YUCCA MOUNTAIN – SUPPLEMENTAL RESPONSES TO REQUESTS FOR
ADDITIONAL INFORMATION (RAI) – VOLUME 2, CHAPTER 2.1.1.1, FIRST SET AND
SECOND SET – Site Description

Response Tracking Number: 00035-02-00

RAI: 2.2.1.1.1-001

RAI Volume 2, Chapter 2.1.1.1 Second Set, Number 1: Second Supplemental Question:

Figure 1. Topographic Map of the Geologic Repository Operations Area

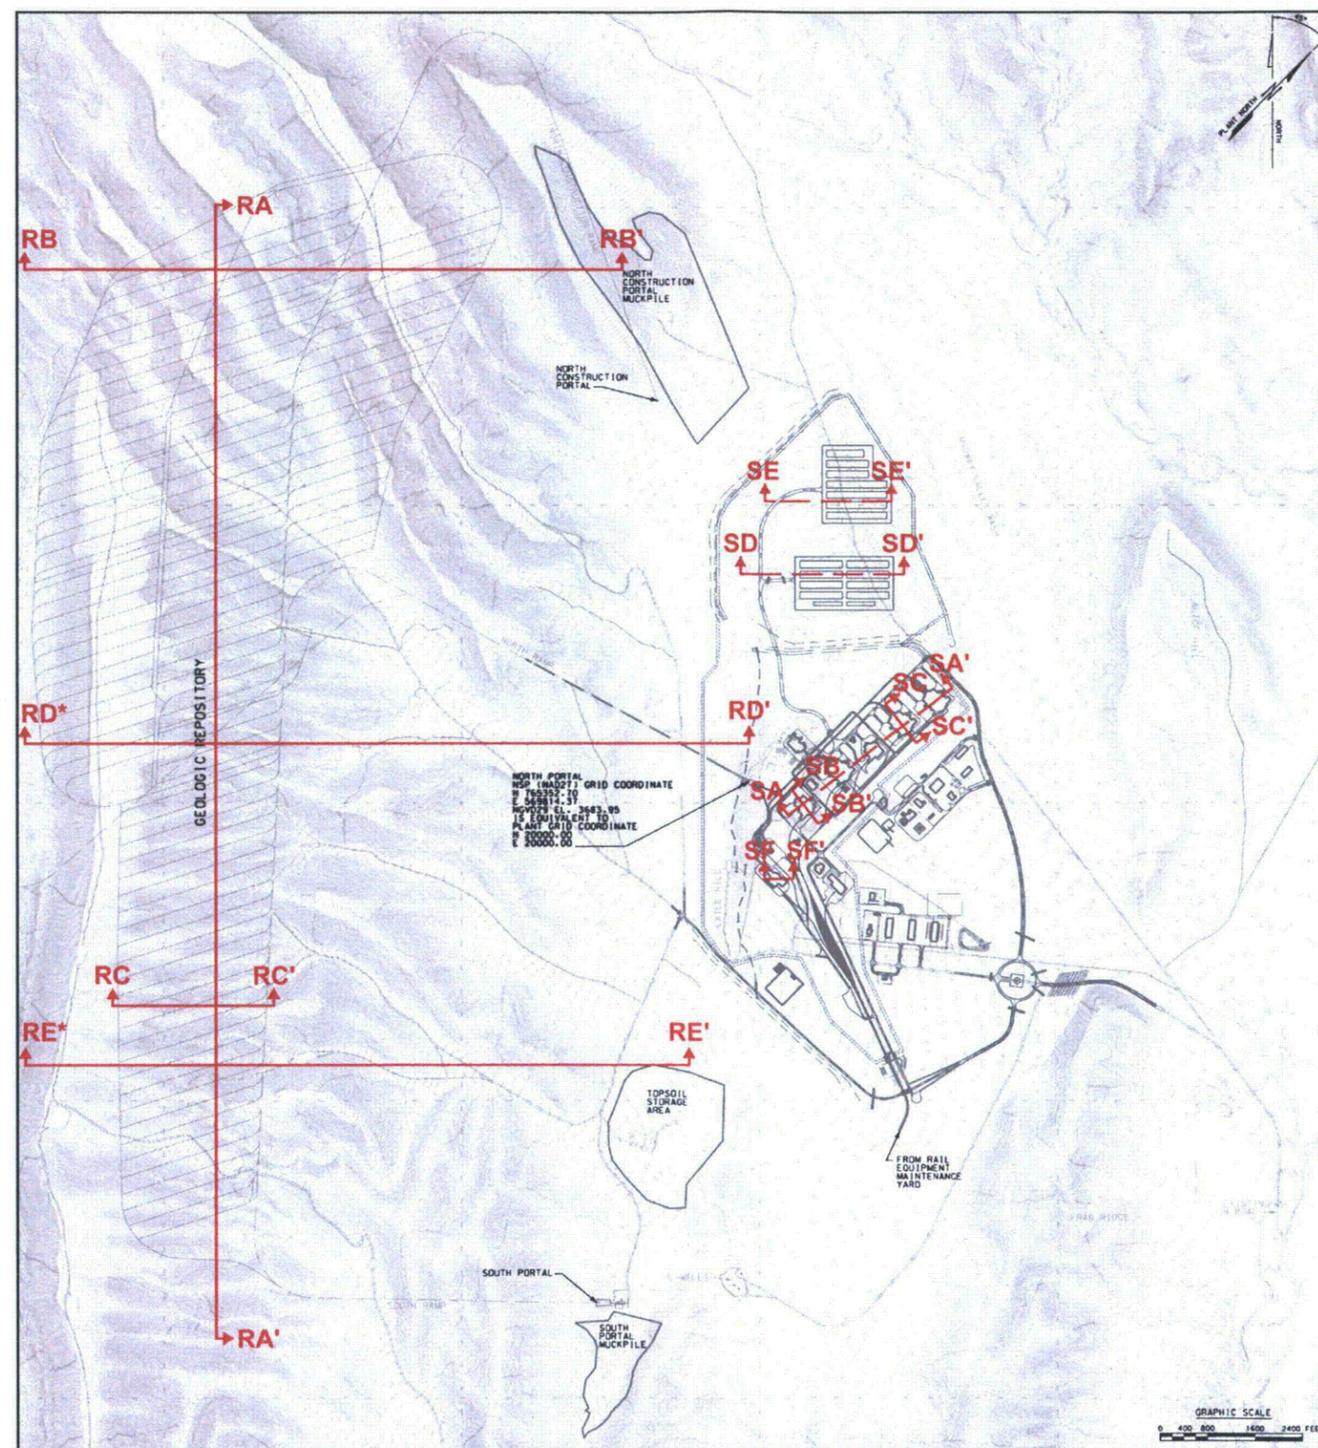
- 1) Clarify between fault maps of the subsurface geologic repository operations area (GROA) (Second Set, Number 1, dated February 4, 2009, Figure 4 and SAR Figure 1.1-61), and of the surface GROA (Second Set, Number 1, dated March 20, 2009, Figure 1 and SAR Figure 1.1-64) by showing the current map, which includes the areas between the Solitario Canyon Fault, Bow Ridge Fault, and Paintbrush Canyon Fault or areas near the Paintbrush Canyon Fault.

- Figures 1 and 3 include new cross-sections RD–RD' and RE–RE' and identify the greater widths of the cross-sections being submitted as part of this response.

Figure 3. Underground Layout Configuration and Geologic Units of Emplacement Area

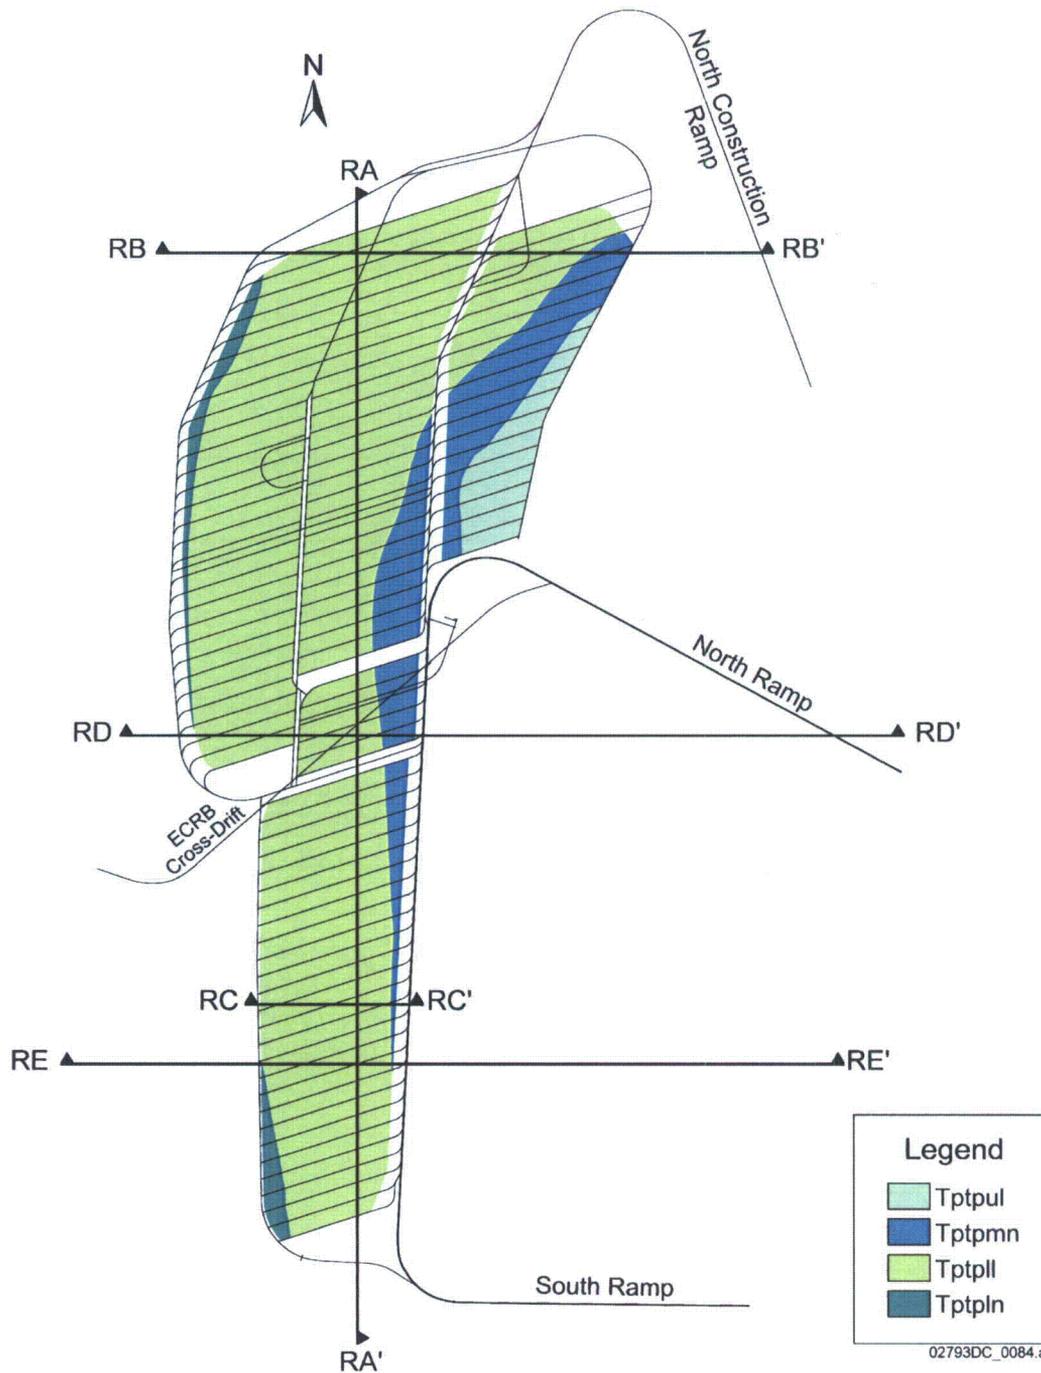
- 3) RAI 2.2.1.1.1-2-003, p. 8—Clarify certain incomplete cross-sections (or resubmit cross-sections) to show the spatial relationship of the major faults of significant displacements or faults that influence GROA design, as well as the named and unnamed identified faults shown on the surface and subsurface GROA.
